# UNITED STATES PATENT AND TRADEMARK OFFICE

APPLICATION NO.	FILING DATE	FIRST NAMED INVENTOR	ATTORNEY DOCKET NO.	CONFIRMATION N
10/697,815	10/29/2003	John Trezza	4024-4043	9556
27123	7590	08/10/2005	EXAMINER	
MORGAN & FINNEGAN, L.L.P. 3 WORLD FINANCIAL CENTER NEW YORK, NY 10281-2101			NGUYEN, PHILLIP	
			ART UNIT	PAPER NUMBER
			2828

## Office Action Summary

## DETAILED ACTION

**Fig. 3**

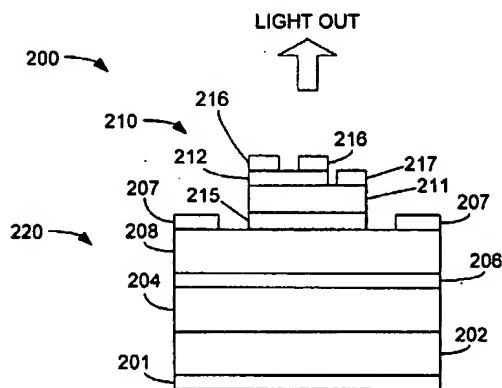
With respect to claim 1, Aronson discloses in Fig. 3 a laser-based device comprising a VCSEL-type laser having an active side 220 and a passive side 210 opposite the active side; and a photodetector 210 unit on the passive side, the photodetector unit comprising an absorbing region located so as to receive leakage photons exiting the laser through the passive side, and a

"Schottkey" contact 212 having a first portion abutting the absorbing region (in the photodetector section) and through which a current, caused by absorption of the leakage photons in the absorbing, can be measured.

With respect to claims 2 and 4, Aronson discloses a substrate 202 abutting the active side.

With respect to claim 3, Aronson discloses an access way over at least a portion of the active side (window from 215) so that, when the laser emits light through the active side, the emission will pass through the access way.

With respect to claims 10-11, Aronson discloses in active side comprising an active side mirror 104/204/304 for being p-type. However, Aronson also teaches p-type could be replaced with n-type (col. 11, lines 7-11) and the mirror consists AlGaAs.

With respect to claims 12 and 13, Aronson discloses the photodetector having absorbing region 215 being semiconductor material which is also considered as semi-insulating material comprising GaAs (AlGaAs).
